NUCLEAR ENERGY INSTITUTE

# NEI 17-02

## **Tornado Missile Risk Evaluator (TMRE) – Resolution of NRC Staff Comments**

Figure 3-1. Plan View of Safety Related Structures

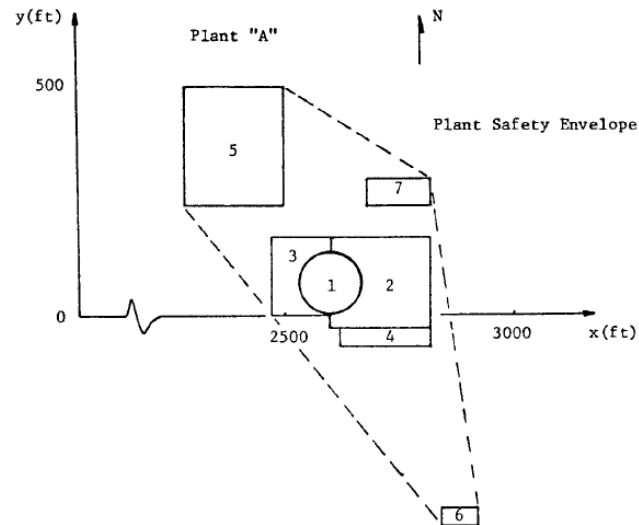
- Building 1 (Containment) is 230 feet tall, but lower portion of building is completely shielded by Buildings 2 (Aux Bldg) and 3 (Fuel Handling Bldg)
  - Aux Bldg is 80 feet tall and Fuel Handling Bldg is 60 feet tall, so all exposed surfaces of Building 1 are >30' above grade
- EPRI NP-768 Plant A TORMIS simulations assume uniform distribution of initial missile elevations from 5' to 50' above grade, so some missiles are within 30' of exposed surface on west (FHB) side of Building 1

- Use of containment data in deriving <30' MIP leads to lower (less conservative) <30' MIPs
- >30' MIPs are derived in a conservative manner, since they include entire surface of all buildings, including surfaces less than 30' above grade
- TMRE methodology provides conservative tornado failure probabilities, when compared to TORMIS-based failure probabilities in RG 1.200 HW PRAs (Appendix A)
- Sensitivity case factors (2.5x and 2.75x) are significantly greater than increase in MIP, if it were derived without Building 1
